APPROVALS		TITLE:	
INIT	DATE	BACKLINE 112 PRE-AMP	
DESIGNED: R.A.G.	10/01/01	SIZE	DRAWING NO: 406-0150-A
DRAWN: R.A.G.	10/8/01	B	PART NO: 206-0150-A
ELEC:		COMPANY: GALLIEN-KRUEGER	
MECH:		FILENAME: 6150A Backline 112 Preamp.sch	
Q/A:			
RELEASED:

Bill of Materials Backline 112/110 Preamp 206-0150-A

Customer Name:		Gallien-Krueger		Current Rev #:		A1		New ECO Rev #:		A2	
Model:		Backline 110/112				Page:		1		Of: 1	
Assembly Description:		Preamp Assembly		Originator:		Bob Gallien					
Assembly Numbers:		206-0150-A1		Approved by:							
				Effective Date:		12/21/2001					
Effective				Document Update				Date		Initials	
<input checked="" type="checkbox"/>	All in Process	<input checked="" type="checkbox"/>	Next Buy	<input type="checkbox"/>	Artwork						
<input type="checkbox"/>	All in Service	<input checked="" type="checkbox"/>	Next Production Run	<input type="checkbox"/>	Assembly Dwg.						
<input type="checkbox"/>	All in Stock	<input type="checkbox"/>		<input type="checkbox"/>	Auto Insert Pgm						
Beginning Serial Number:				<input type="checkbox"/>	Board Artwork						
Reason For Change				<input checked="" type="checkbox"/>	BOM	#####					AV
The Overdrive B channel has too much g

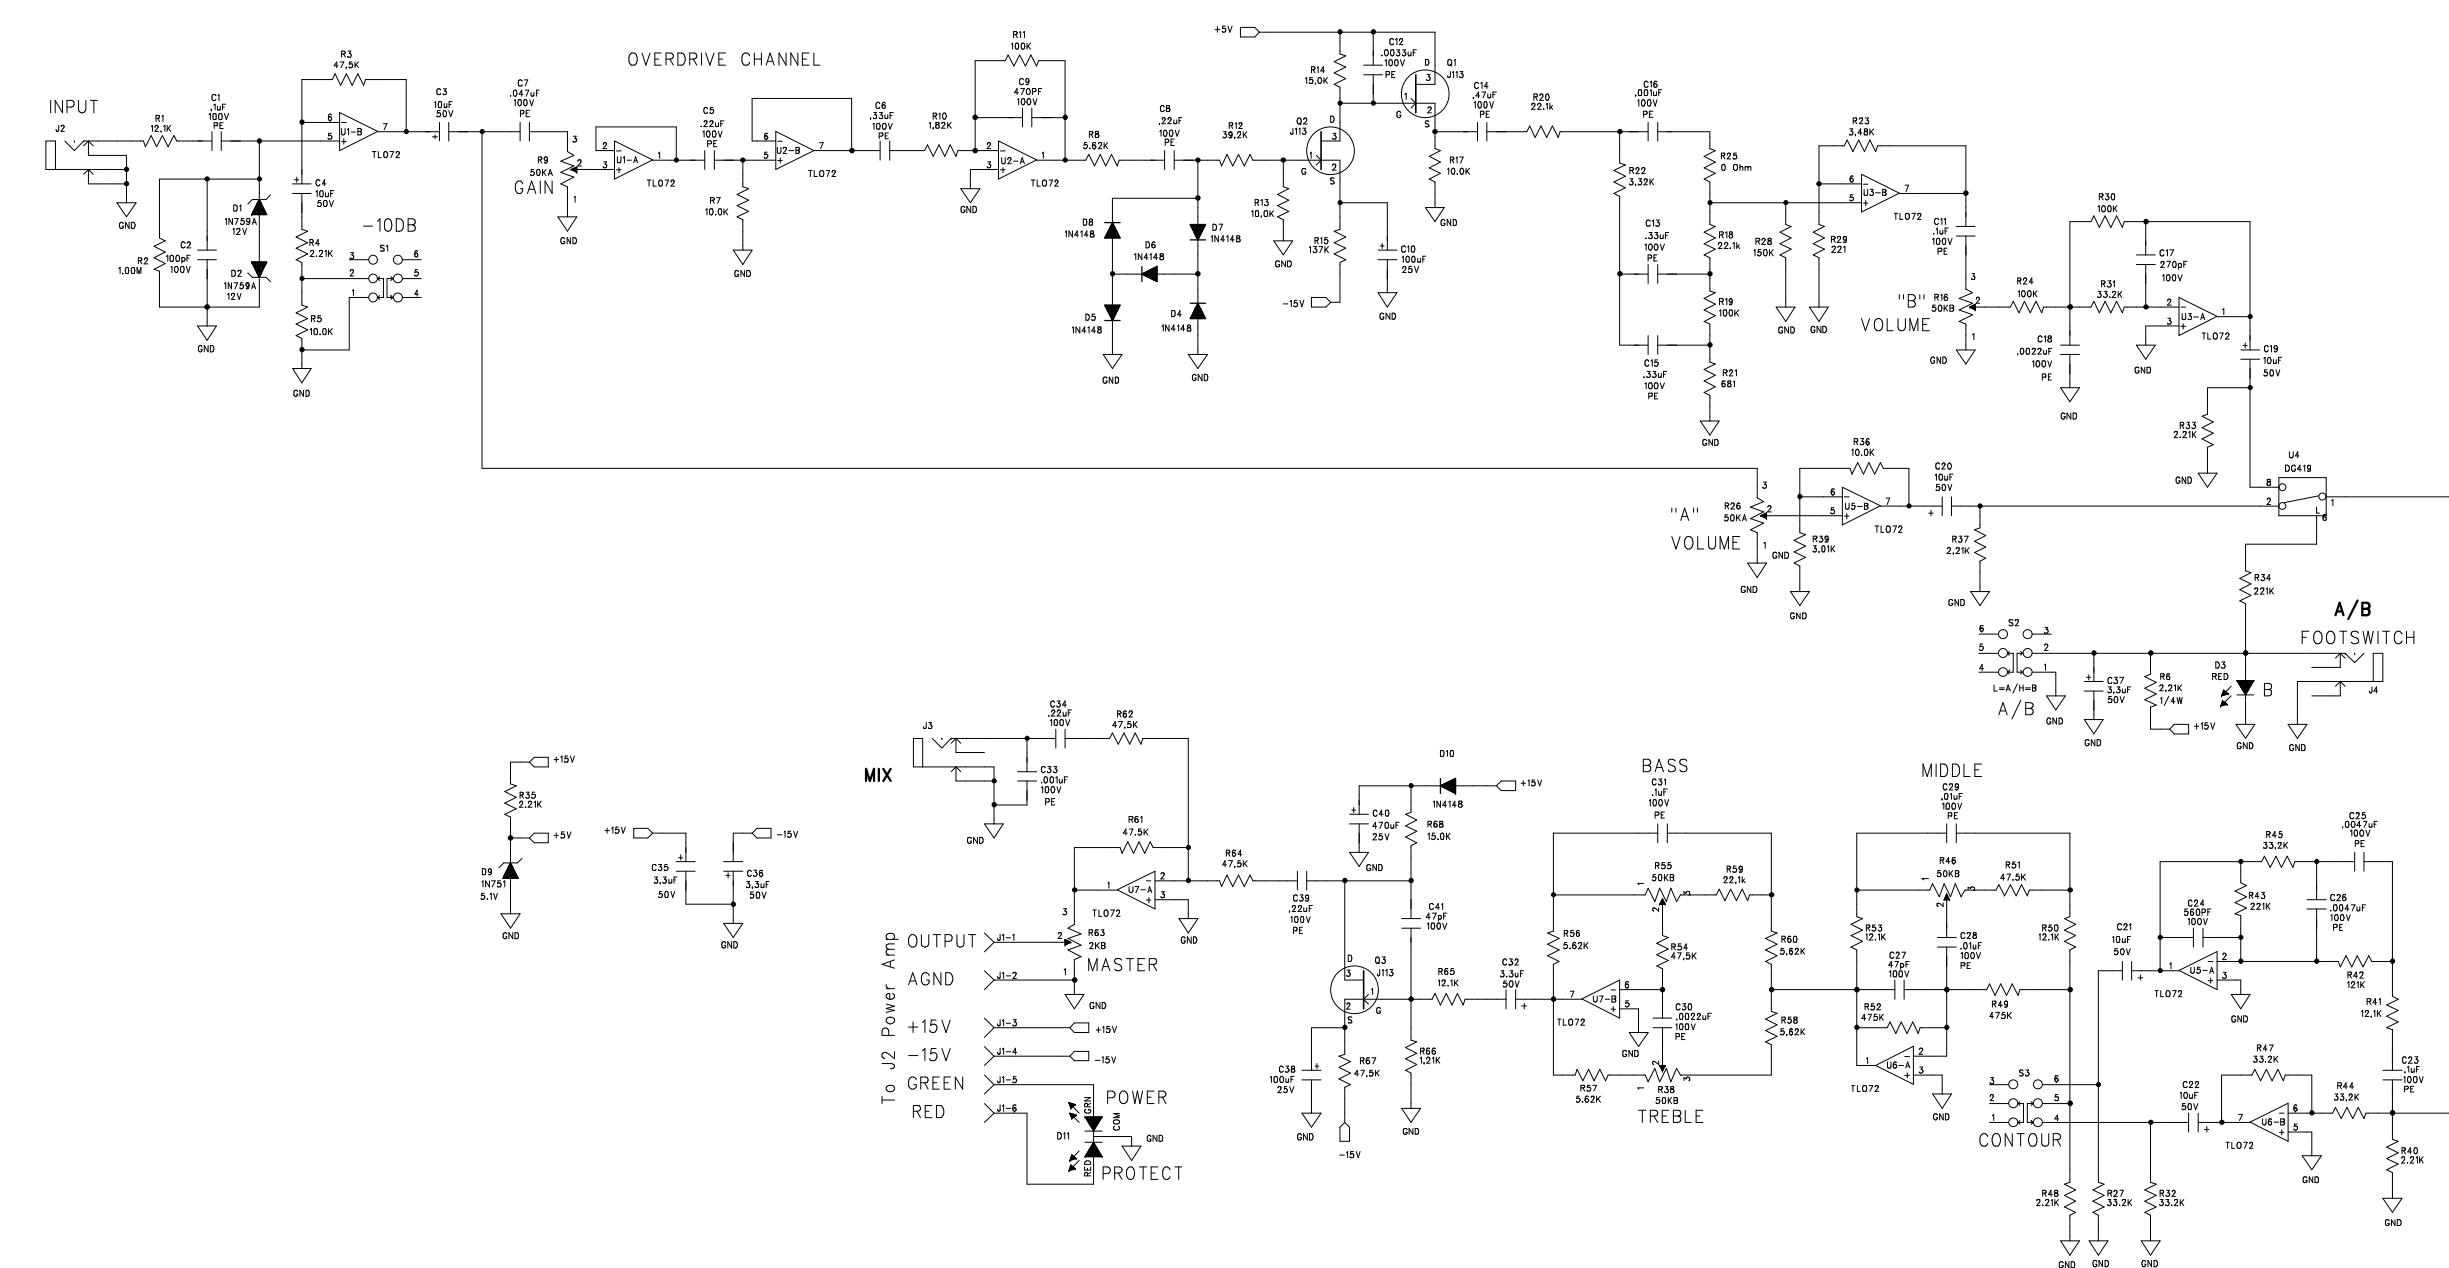
1. Change R5 from 8.25K to 10.0K.		<input type="checkbox"/>	Accounting		
2. Update all pad and hole sizes.		<input type="checkbox"/>	Assembly		
3. Change board number from 206-0150-B2 to 206-0191-A.		<input type="checkbox"/>	Customer		
		<input checked="" type="checkbox"/>	Engineering		
		<input type="checkbox"/>	Fabrication		
		<input checked="" type="checkbox"/>	Incoming Q.C.		
		<input type="checkbox"/>	Planning		
		<input checked="" type="checkbox"/>	Production Eng.		
		<input checked="" type="checkbox"/>	Purchasing		
		<input type="checkbox"/>	Q.A.		
		<input type="checkbox"/>	Receiving		
		<input type="checkbox"/>	Service		
		<input type="checkbox"/>	Vendor		
		<input checked="" type="checkbox"/>	Test		
		<input type="checkbox"/>			
<input type="checkbox"/>	Continued on ECO Supplement Page		<input type="checkbox"/>	Drawing(s) attached	
Part Number	Description	Parts Added		Parts Deleted	
		Qty	Ref. Designator	Qty	Ref. Designator

1. CHANGE R5 TO 10.0K FROM 8.25K.		APPROVALS		TITLE: BACKLINE 110/112 PRE-AMP	
2. UPDATE ALL PAD AND HOLE SIZES.		INIT	DATE	DESIGNED: R.A.G.	10/01/01
3. CHANGE BOARD NO. TO 206-0191-A FROM 206-0150-B2.		DRAWN: R.A.G.	12/6/02	DRAWING NO: 406-0191-A	REV. A
		ELEC:		PART NO: 206-0191-A	
		MECH:		COMPANY: GALLIEN-KRUEGER	
		D/A:		FILENAME: 6191A	
		RELEASED:

060-8252-0	8.251k, 1/8W, 1%			1	R5
060-1003-0	10.0K, 1/8W, 1%	1	R5

DESIGNED: R.A.G.	DATE: 10/03/01	REV: B	TITLE: BACKLINE 110/112 PRE-AMP
DRAWN: A.T.M.	DATE: 04/07/04	REV: B	DRAWING NO: 406-0191-A
ELEC:			PART NO: 206-0191-A
MECH:			COMPANY: GALLIEN-KRUEGER
S/A:			FILENAME: 6191A
RELEASED:

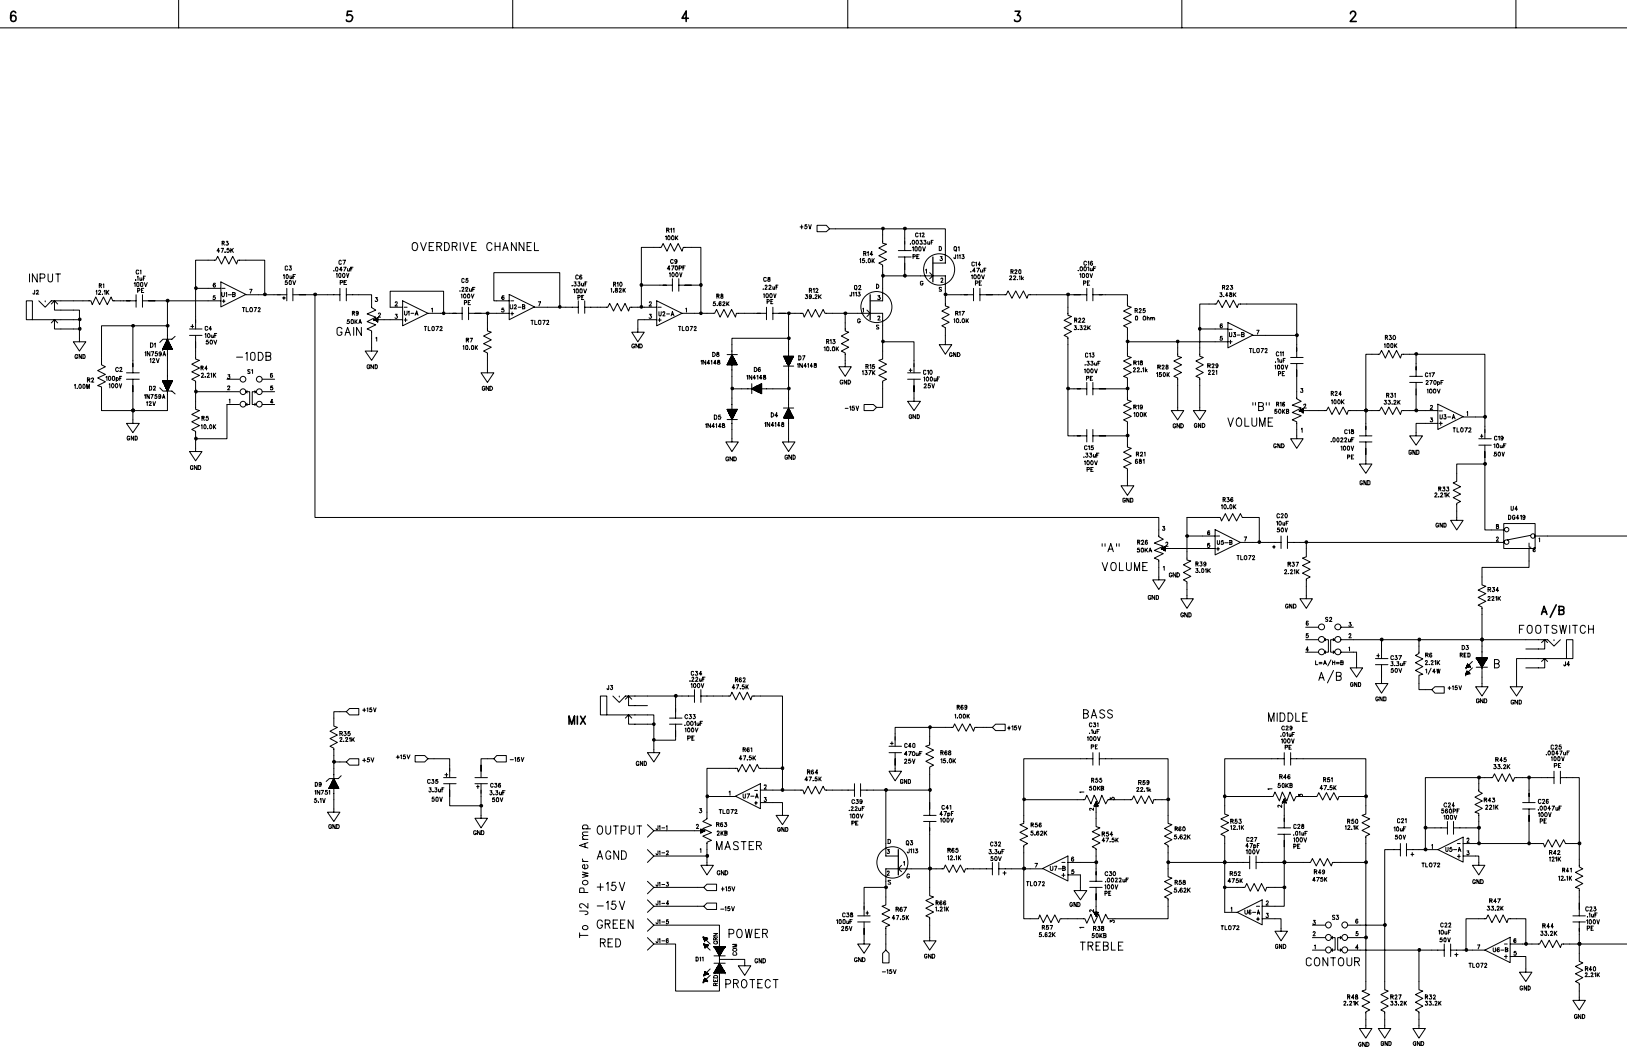
Customer Name:	Gallien-Krueger	Current Rev #:	A	New ECO Rev #:	A1
Model:	Backline 110/112	Page:	1	Of:	1
Assembly Description:	Preamp Assembly	Originator:	Arnel Millet		
Assembly Numbers:	206-0191-A	Approved by:			
		Effective Date:	4/20/2004		
Effective		Document Update		Date	Initials
<input checked="" type="checkbox"/>	All in Process	<input checked="" type="checkbox"/>	Artwork		
<input checked="" type="checkbox"/>	All in Service	<input checked="" type="checkbox"/>	Assembly Dwg.		
<input checked="" type="checkbox"/>	All in Stock	<input type="checkbox"/>	Auto Insert Pgm		
Beginning Serial Number:		<input type="checkbox"/>	Board Artwork		
Reason For Change		<input checked="" type="checkbox"/>	BOM	4/20/2004	AM
The BOOST circuit is loosing its bias causing the amp to loose the signal during normal playing.		<input type="checkbox"/>	Control Form		
		<input type="checkbox"/>	Costing		
		<input type="checkbox"/>	Fab Drawing

1. Replace D10 with R68, 1.0K resistor.

<input type="checkbox"/>	Planning		
		<input checked="" type="checkbox"/>	Production Eng.		
		<input checked="" type="checkbox"/>	Purchasing		
		<input type="checkbox"/>	Q.A.		
		<input type="checkbox"/>	Receiving		
		<input type="checkbox"/>	Service		
Update board # from 206-0191-A to 206-0191-A1		<input type="checkbox"/>	Vendor		
		<input checked="" type="checkbox"/>	Test		
		<input type="checkbox"/>			
<input type="checkbox"/>	Continued on ECO Supplement Page		<input type="checkbox"/>	Drawing(s) attached	
Part Number	Description	Parts Added		Parts Deleted	
		Qty	Ref. Designator	Qty	Ref. Designator
020-1000-0	1N4148, DIODE			1	D10
060-1002-0	1.0K, 1/8W, 1%	1	R69
